Response to U.S. EPR Design Certification Application RAI No. 471, Supplement 10

Response to
Request for Additional Information No. 471(5387, 5426, 5389), Supplement 10,
Revision 0

U. S. EPR Standard Design Certification

Docket No. 52-020

Figure 19.2-5—Hydrogen Concentrations through the U.S. EPR Containment

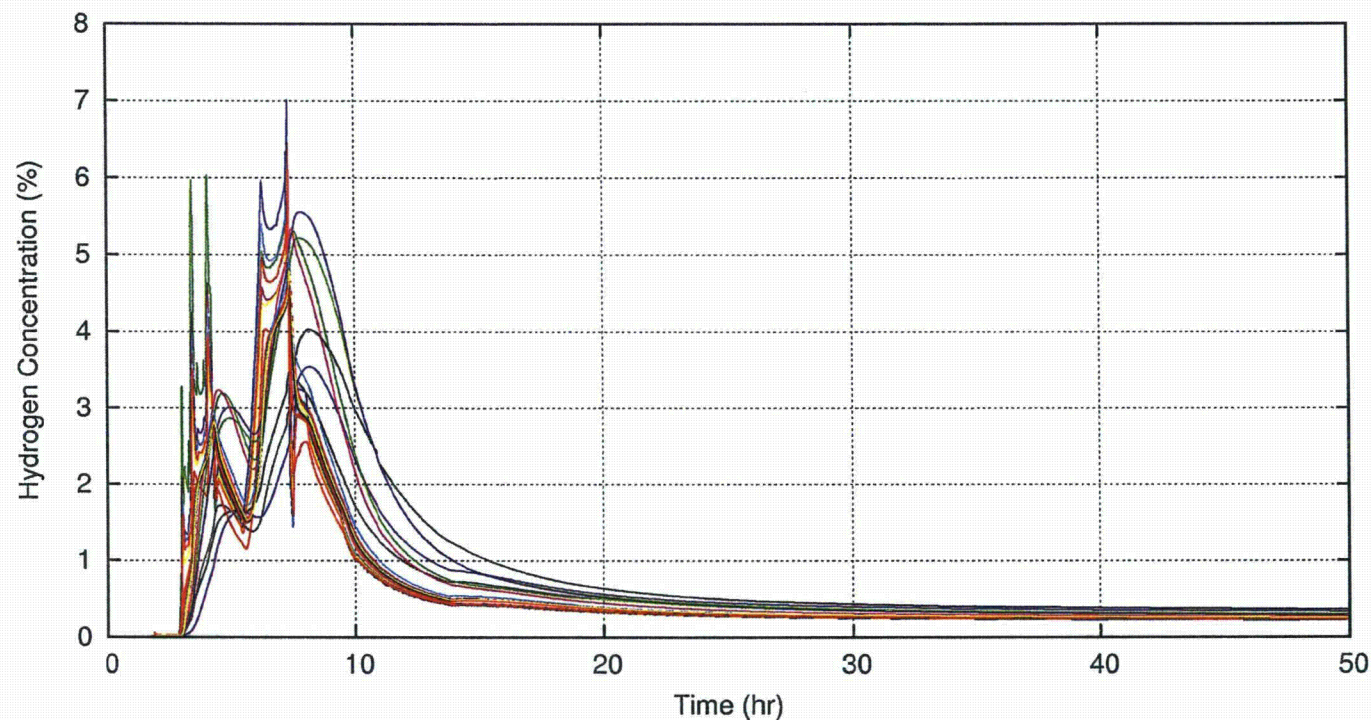
The staff performed confirmatory calculations and sensitivity studies and compared the results to calculations performed by AREVA. The confirmatory calculations generally showed higher hydrogen concentrations in the staff calculation and noted the dominant sensitivity was the efficiency of the PARs. In order for staff to understand the differences between the two analyses, provide the input assumptions for the FSAR figure 19.2-5, including:

- a. % PARs effective, and at what efficiency
- b. % foils open
- c. % dampers open
- d. Number of open safety related doors in pressurizer rooms
- e. Identify doors credited with being open, other than in pressurizer rooms.
- f. Time period in accident scenario when H₂ from MCCI is added to containment

Provide curves for H₂ concentration for all nodes vs. time with 100% of the PARs at 100% efficiency. Provide curves for H₂ concentration for all nodes vs. time with 100% of the PARs at 50% efficiency.

- a) U.S. EPR FSAR Tier 2, Figure 19.2-5—Hydrogen Concentrations through the U.S. EPR Containment is a plot of Case 01 of the uncertainty analysis. In this scenario, it is assumed that 100 percent of the passive autocatalytic recombiners (PARs) are active, and that the PARs are operating at 94.5 percent efficiency.
- b) The timing for the opening of junctions that represent the rupture/convection foils in the U.S. EPR design are shown in Table 06.02.05-20-1—Rupture/Convection Foil Opening Timing for the scenario shown on U.S. EPR FSAR Tier 2, Figure 19.2-5 (Case 01 of the uncertainty analysis).

- d) A review of the results of the scenario shown on U.S. EPR FSAR Tier 2, Figure 19.2-5 (Case 01 of the uncertainty analysis) shows that no doors in the pressurizer rooms are predicted to open.
- e) A review of the results of the scenario shown on U.S. EPR FSAR Tier 2, Figure 19.2-5 (Case 01 of the uncertainty analysis) shows that no doors in the remainder of the containment compartments are predicted to open.
- f) For the scenario shown on U.S. EPR FSAR Tier 2, Figure 19.2-5 (Case 01 of the uncertainty analysis), hydrogen production because of molten corium-to-concrete interaction begins 5.5 hours into the accident and ends 8.1 hours into the accident.

Curves for hydrogen concentration because of 100 percent of the PARs at 100 percent efficiency, and 100 percent of the PARs at 50 percent efficiency were provided as part of the Response to RAI 553, Question 06.02.05-31, Part a) with respect to the four relevant scenarios. Results for the [] are described in this Response.

In U.S. EPR FSAR Tier 2, Section 19.2.4.4.1.3 the second paragraph will be replaced and additional text will be added to the third paragraph in order to describe better the results from the updated analysis discussed in this section. U.S. EPR FSAR Tier 2, Figure 19.2-5 will also be replaced to show the updated analysis results.

U.S. EPR FSAR Tier 2, Figure 19.2-5 will be revised as described in the response and indicated on the enclosed markup.

Each trace appearing in Figure 19.2-5 represents a different compartment hydrogen concentration result. The figure shows that the hydrogen concentrations in each node behave similarly, as would be expected for a well-mixed containment atmosphere. Specifically, it can be seen that spikes of hydrogen concentration into specific nodes are very short lived and are followed shortly thereafter by increases in hydrogen concentration in the surrounding nodes. This shows that hydrogen being injected into

one part of the containment is quickly circulated into other adjacent nodes due to the natural circulation flows. The observable differences correspond to the relationship of those compartments to the locations in which hydrogen originally appears. The ~~small~~ variation demonstrates the desired occurrence of global convection and resolves the concern of possible secluded recesses of high concentrations of trapped hydrogen.
